Executive Director's Recommendation

Commission Meeting: April 6, 2017

PROJECT Bird House Renovation and Addition Smithsonian Zoological Park 3001 Connecticut Avenue, NW Washington, DC	NCPC FILE NUMBER 7673 NCPC MAP FILE NUMBER 2.00(38.00)44518
SUBMITTED BY Smithsonian Institution	APPLICANT'S REQUEST Approval of preliminary and final site and building plans
REVIEW AUTHORITY Federal Projects in the District per 40 U.S.C. § 8722(b)(1) and (d)	PROPOSED ACTION Approve preliminary and final site and buildings plans ACTION ITEM TYPE Consent Calendar

Stormwater Management and Erosion Control Plan

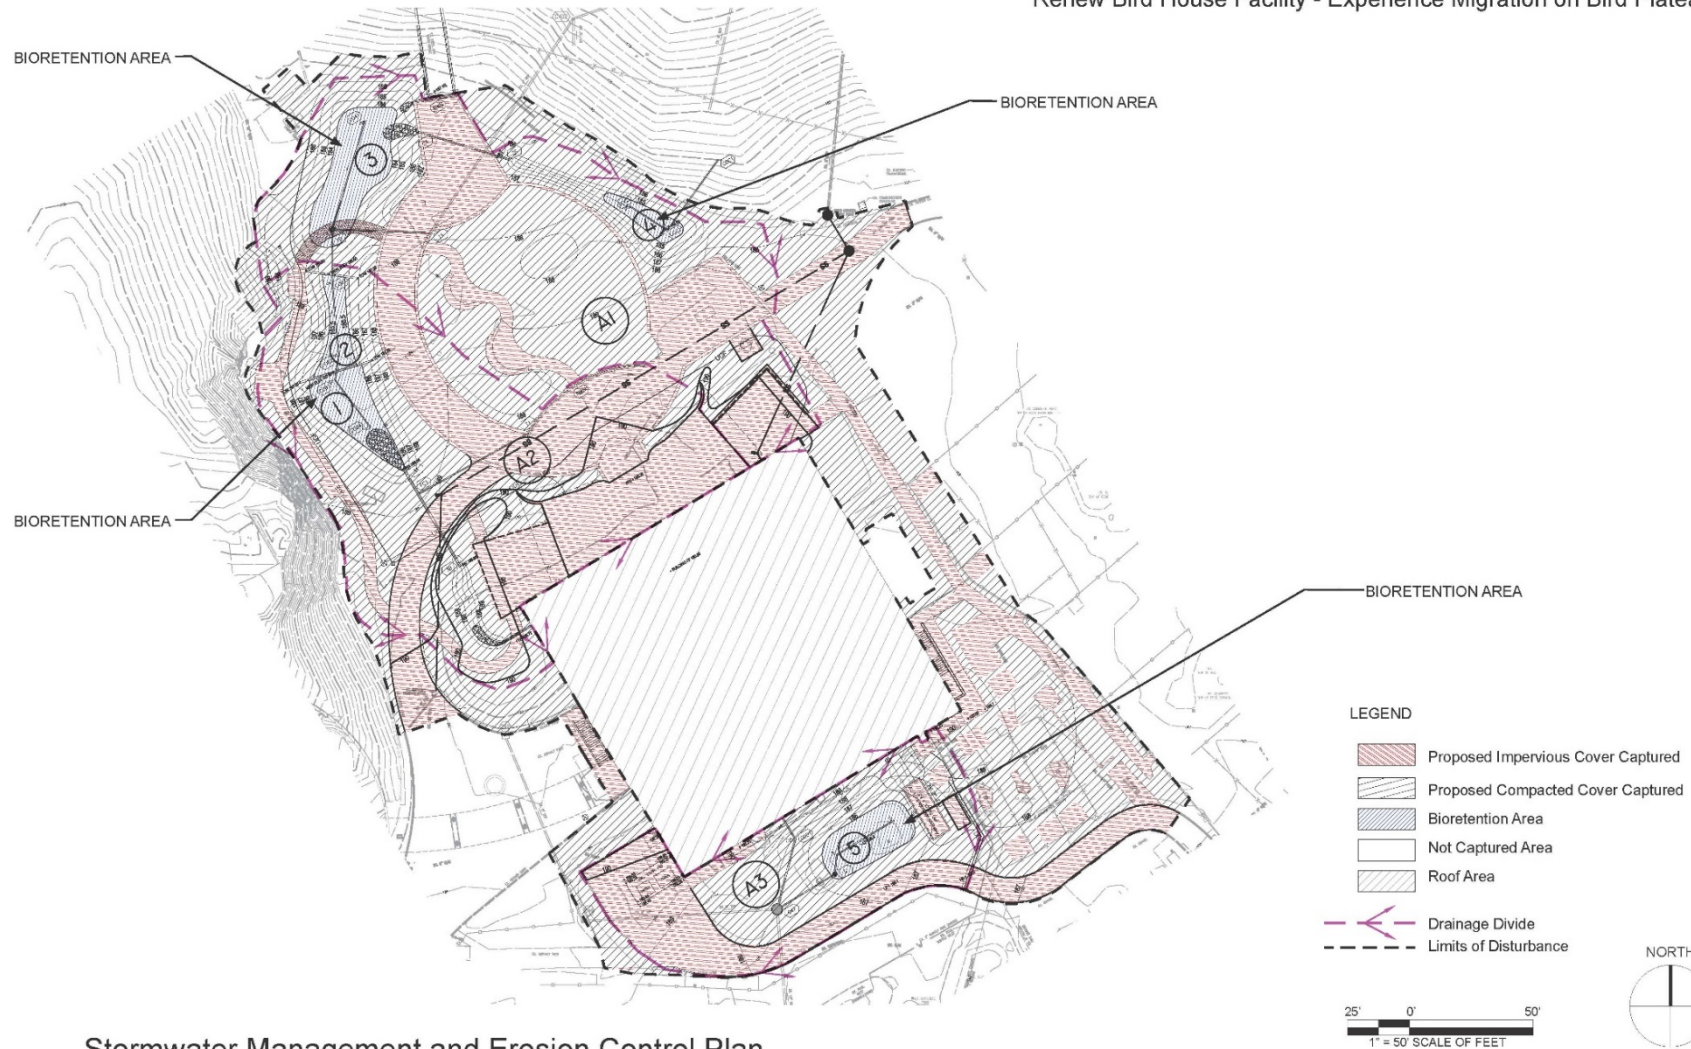
According to the calculations included in the construction documents, the project provides the required Stormwater Retention Volume (SWRv) in accordance with the Department of Energy and Environment (DOEE) Stormwater Management Guidebook. The Bird House Renovation and Addition project provides acceptable stormwater “Best Management Practices” (BMP) by implementing five bioretention areas on site integrated into the landscape design that provide the total required SWRv. The total project site disturbance is approximately 1.53 acres.

Currently the site includes a total of 31,785 square feet (47.7%) of impervious areas and 34,783 square feet (52.3%) of pervious areas. The design proposes a total of 26,477 square feet of impervious areas, plus 2,963 of BMP area (assumed as impervious by DOEE), which equals 29,440 square feet of impervious areas (44.2%) and a total of 37,128 sf (55.8%) pervious area. Therefore, the project decreases impervious area by 3.5%.

Lobby Perspective - Historic Portal

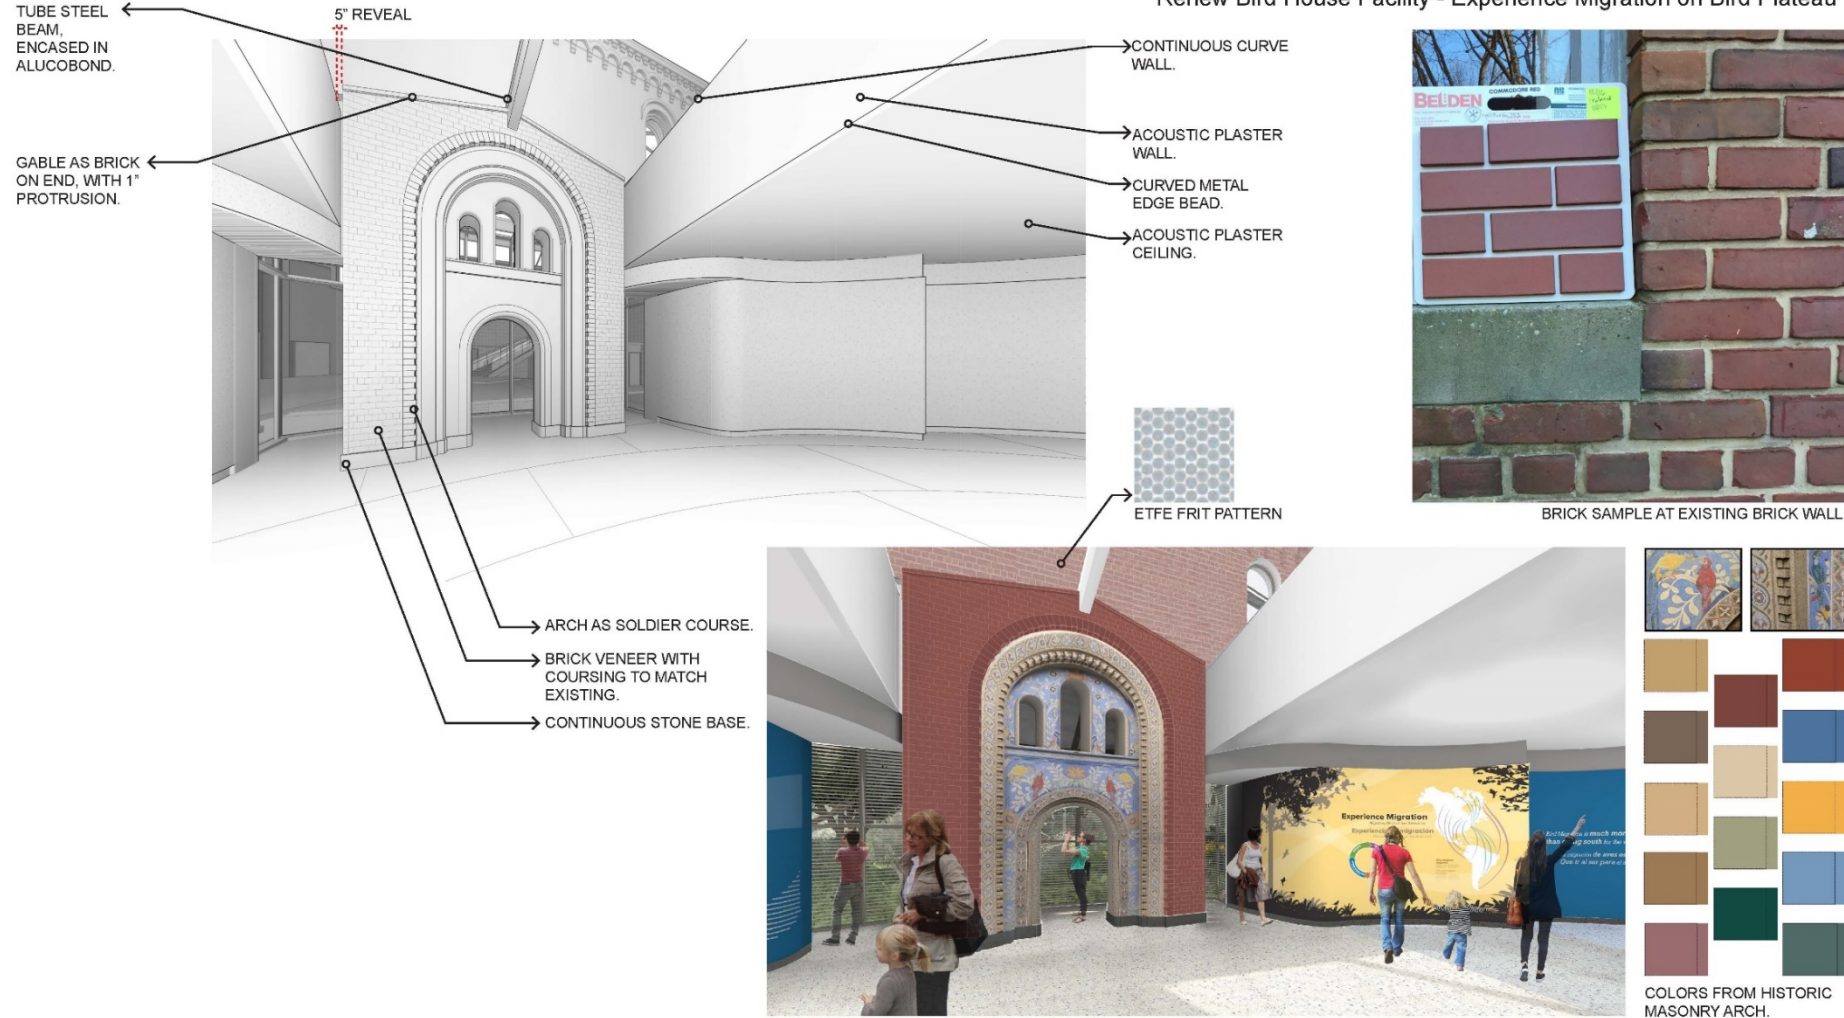
The proposed design introduces a curved building form to express a playful sense of movement. The design includes the relocation of the historic portal, which is currently located in the indoor flight room, to a more prominent location within the building lobby. Upon arrival inside lobby, visitors can go through or around the historic portal to experience the tropical aviary. Additionally, detailing surrounding the portal has been refined to distinguish the ceiling geometry from the portal. This transition announces the variety of migration-themed, light-filled aviaries and intermediary migration exhibit passageways. The design team originally proposed the wall surround of the historic concrete portal to be a Venetian plaster material in a color that is sympathetic to that of the historic masonry. As a result of further consultation with the SHPO, the

surround material of the historic portal fabric will be comprised of face brick with sympathetic (but identifiably new) hue, coursing, and detailing to the historic masonry. The transition between the surround and portal is addressed by an arched soldier course.

The SHPO provided a comment letter on July 29, 2016, concurring that the proposed renovation of the National Zoo Bird House would have “no adverse effect” on historic properties provided that certain conditions were met, including revising and consulting further on the finish of the new interior wall that will be used to frame the historic J.J. Early concrete door surround.

First Floor Plan - Addition of New Flue Enclosure

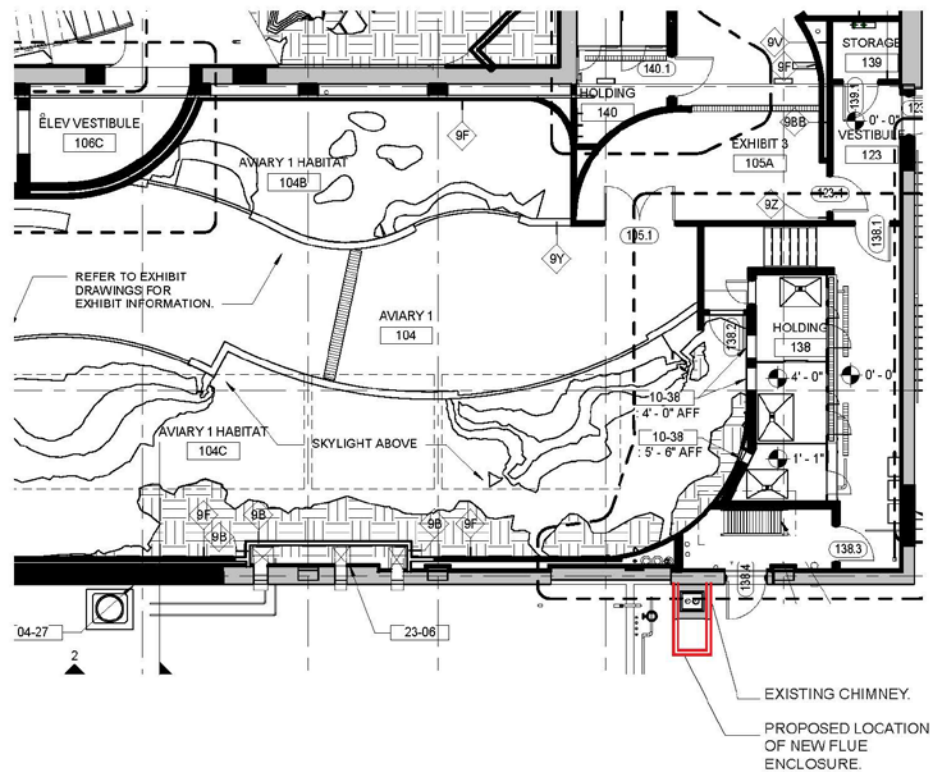
Recent mechanical modeling has introduced the need for a higher elevation exhaust at the back-of-house areas south of the facility. The existing brick chimney, added in 1964, is inadequate to enclose all of the required flues. Therefore, a new brick chimney enclosure will replace the existing structure, modifications will result in a total footprint roughly twice the size of the existing chimney but at the same height. The proposed design has no visual impact on the primary public entrance at the north of the facility; no impact on the historic decorative panel west of the existing chimney; and utilizes a modern brick of sympathetic hue, coursing, and detailing with respect to the historic masonry to the historic masonry.
